STAFF RECOMMENDATION 3609 Katherine Street June 15, 2016

Application: New construction—infill

District: Inglewood Place Neighborhood Conservation Zoning Overlay

Description of Project: Application is to construct infill on a vacant lot that was subdivided from 1132 A McChesney prior to the establishment of the overlay.

KATHERINE STREET
 SCALE 1"=30'
 06.01.16

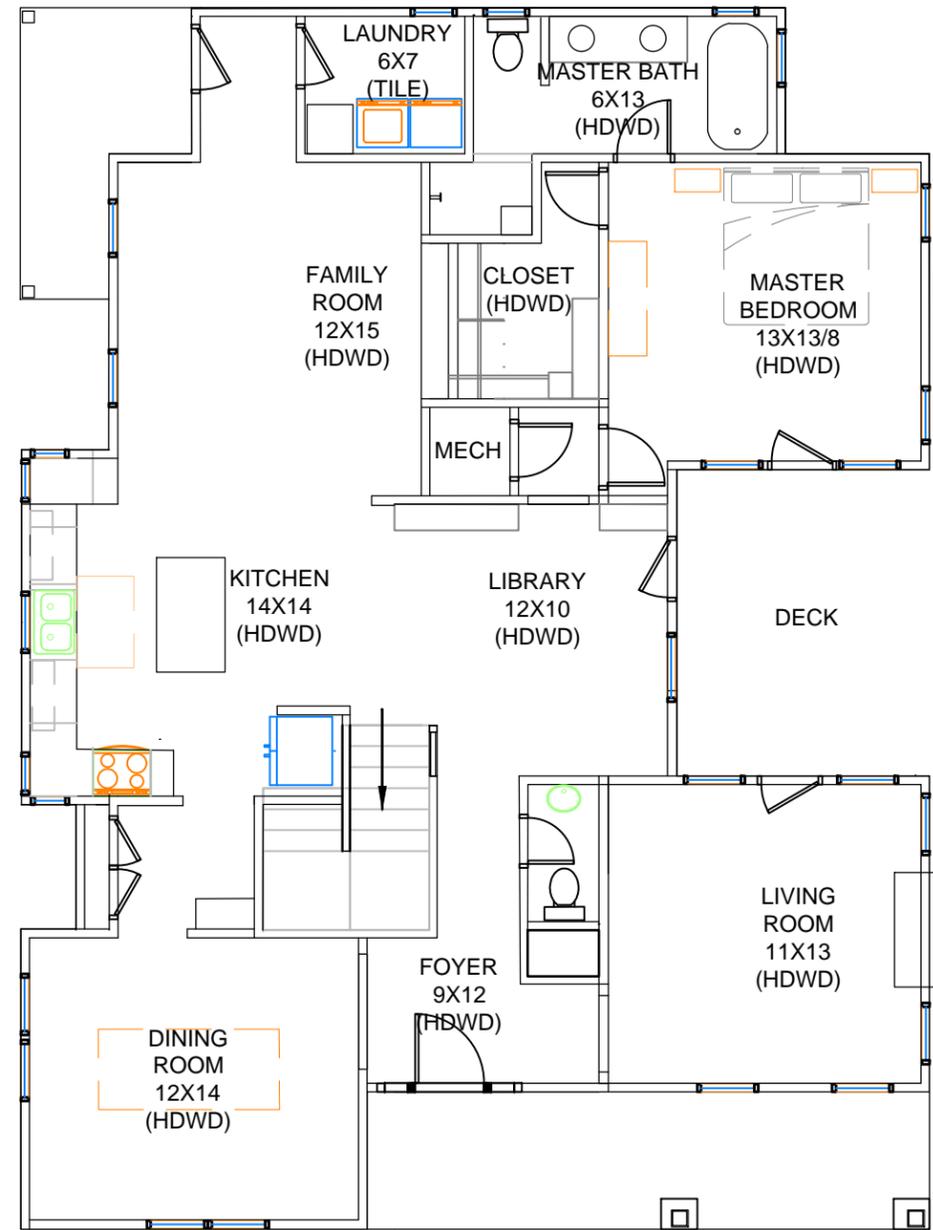
The dimensions and materials of the side deck are not shown on the plans. Staff recommends that it be added to the plans and be approved by Staff prior to issuance of a permit.

This site does not have alley access. The applicant is proposing ten foot (10') wide, single-lane driveway in the location of an existing curb cut. The driveway extends to approximately the midpoint of the house, and staff recommends that the driveway extend to the rear of the house, to prevent "front-yard" parking. In addition, a walkway is shown to connect the driveway to the front porch. Staff recommends that a walkway from the road to the front porch be added. With these conditions, staff finds that the project's orientation is similar to the immediate historic context and meets Section III.F. of the Inglewood Place design guidelines.

7. The driveway extend to the rear of the house, and staff approve the driveway material;
8. A walkway be added from the street to the front porch, and staff approve the walkway material;

LEFT SIDE ELEVATION

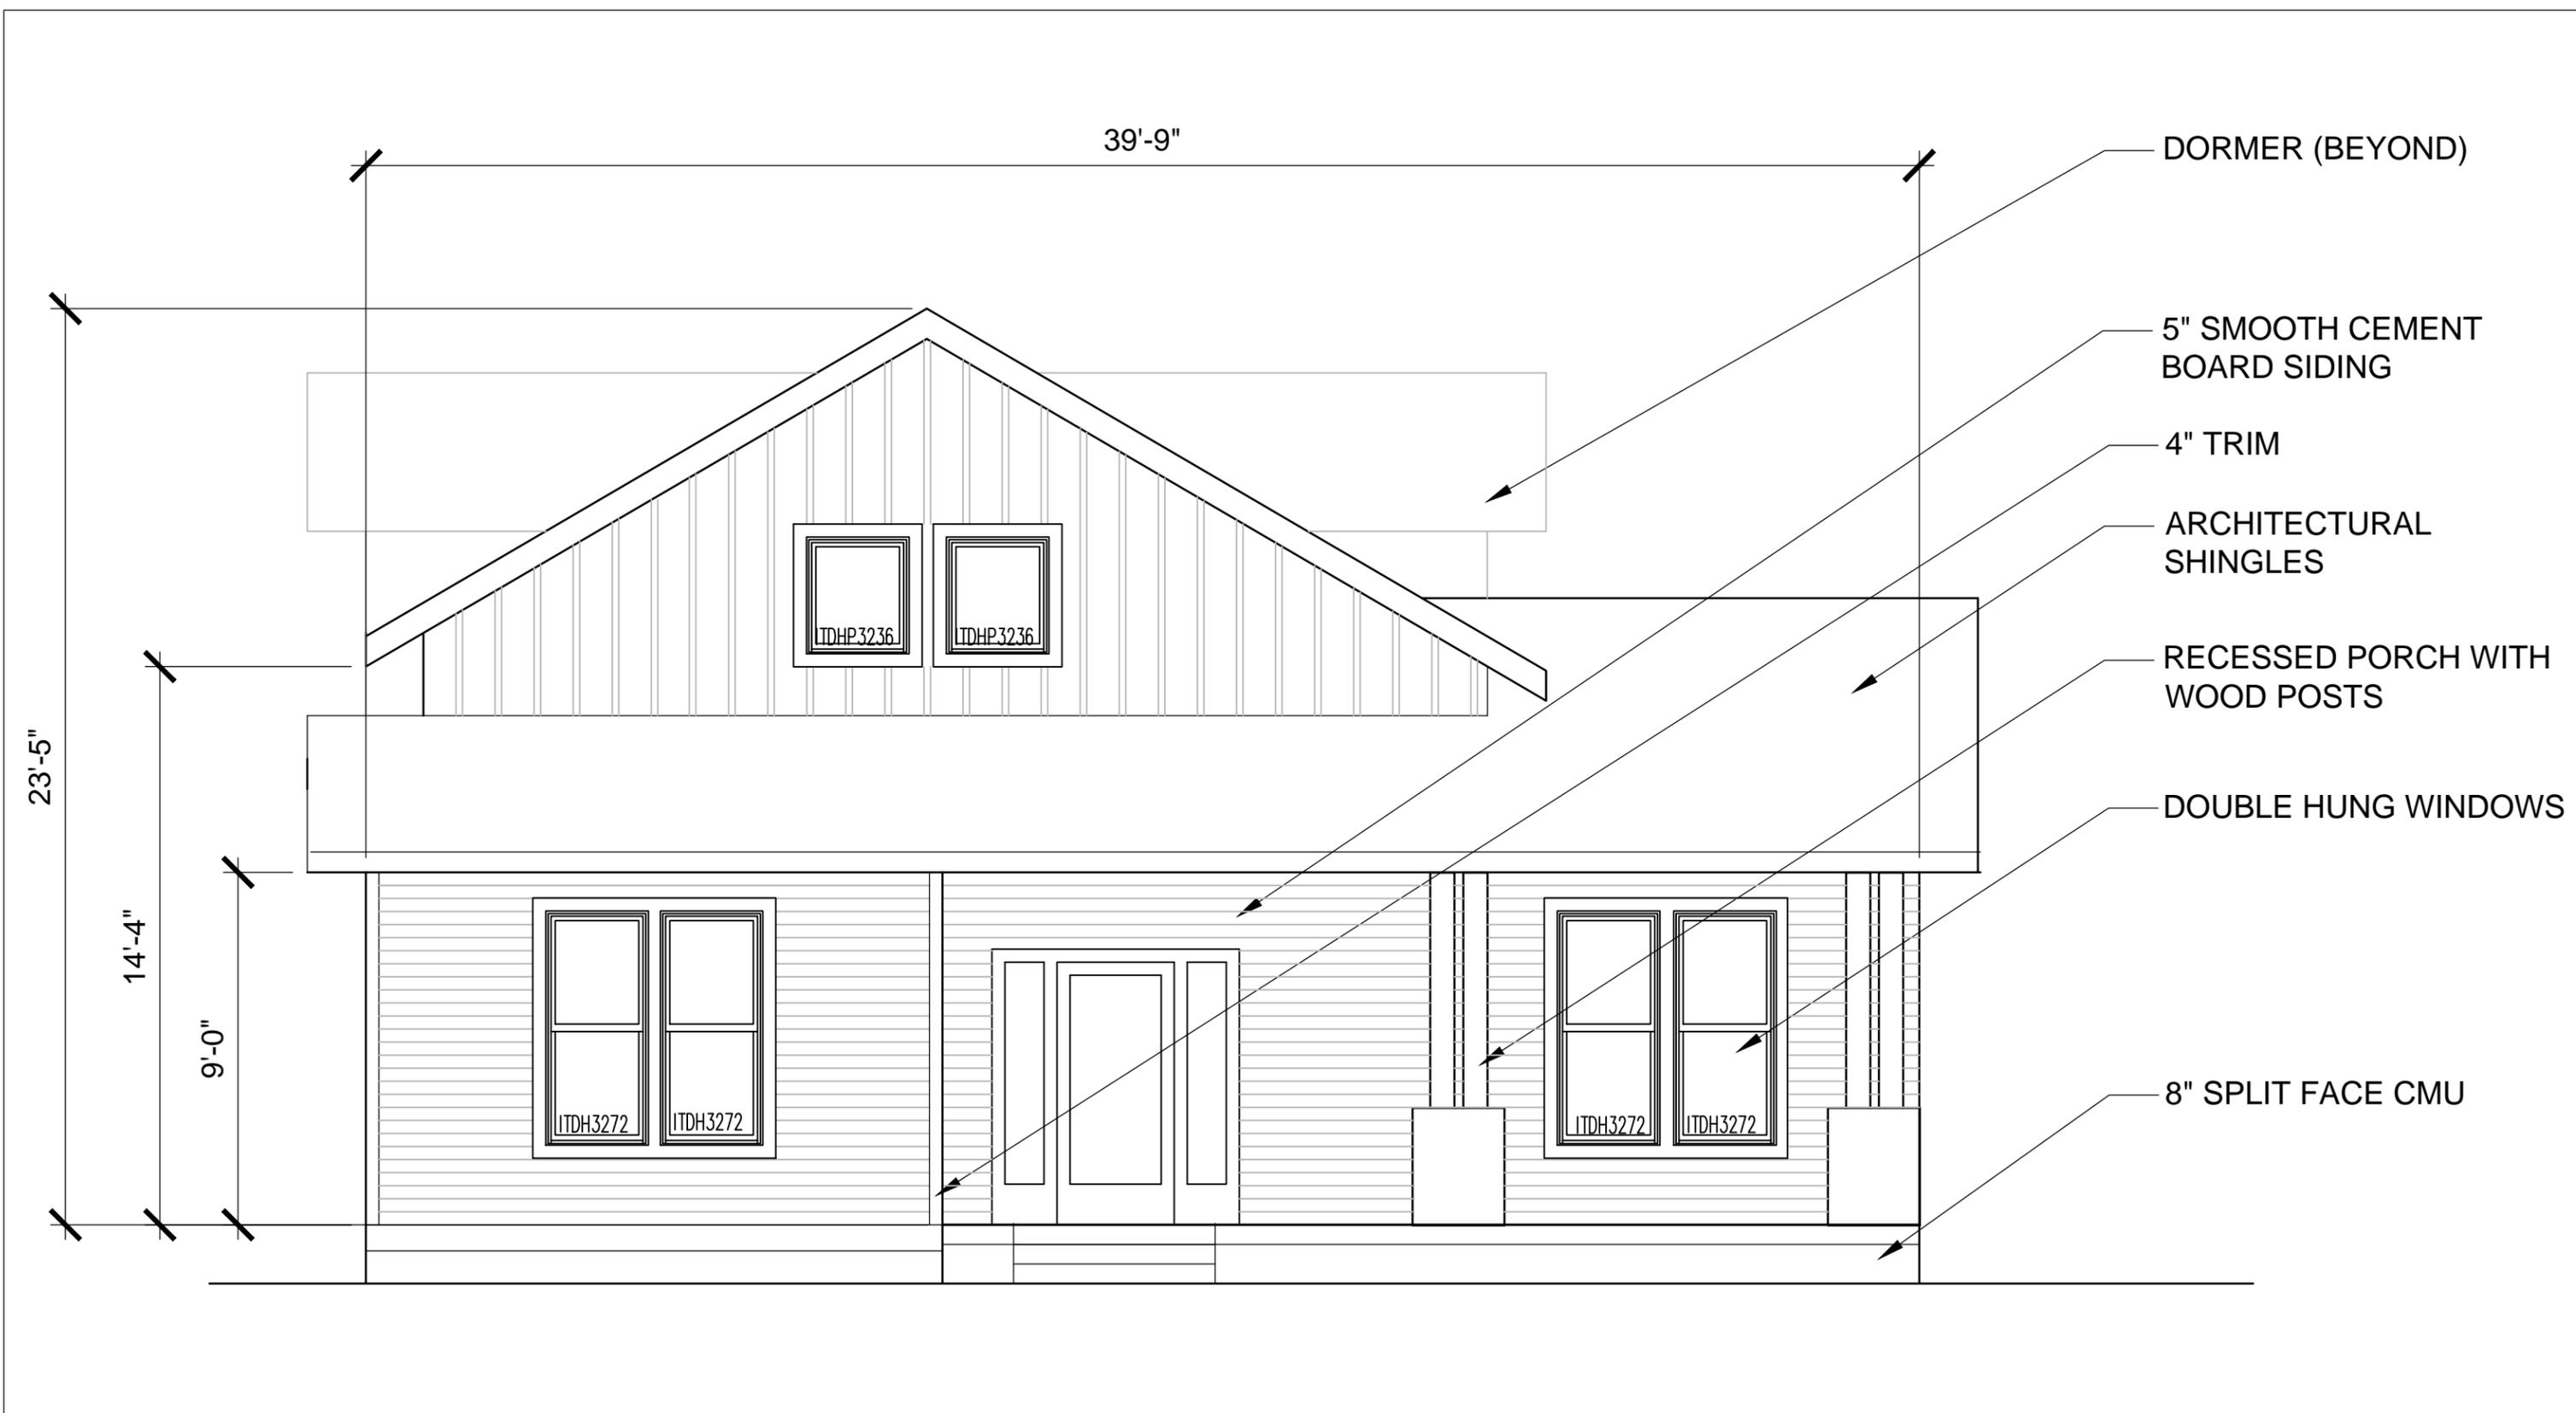
Staff finds that the proposed height and scale are similar to historic buildings in the neighborhood. The left side elevation does have a two-story bay element, with twenty-foot (20') tall eaves. Staff finds this element to be appropriate because it is setback at about the midpoint of the structure, approximately eighteen feet, six inches (18'6") from the front wall of the house. It is no wider than the front of the house, and it extends only eighteen inches (18") beyond the main wall of the house. It is fifteen feet (15') deep. Staff finds that this two-story bay is scaled so as to minimize its impact on the historic neighborhood.
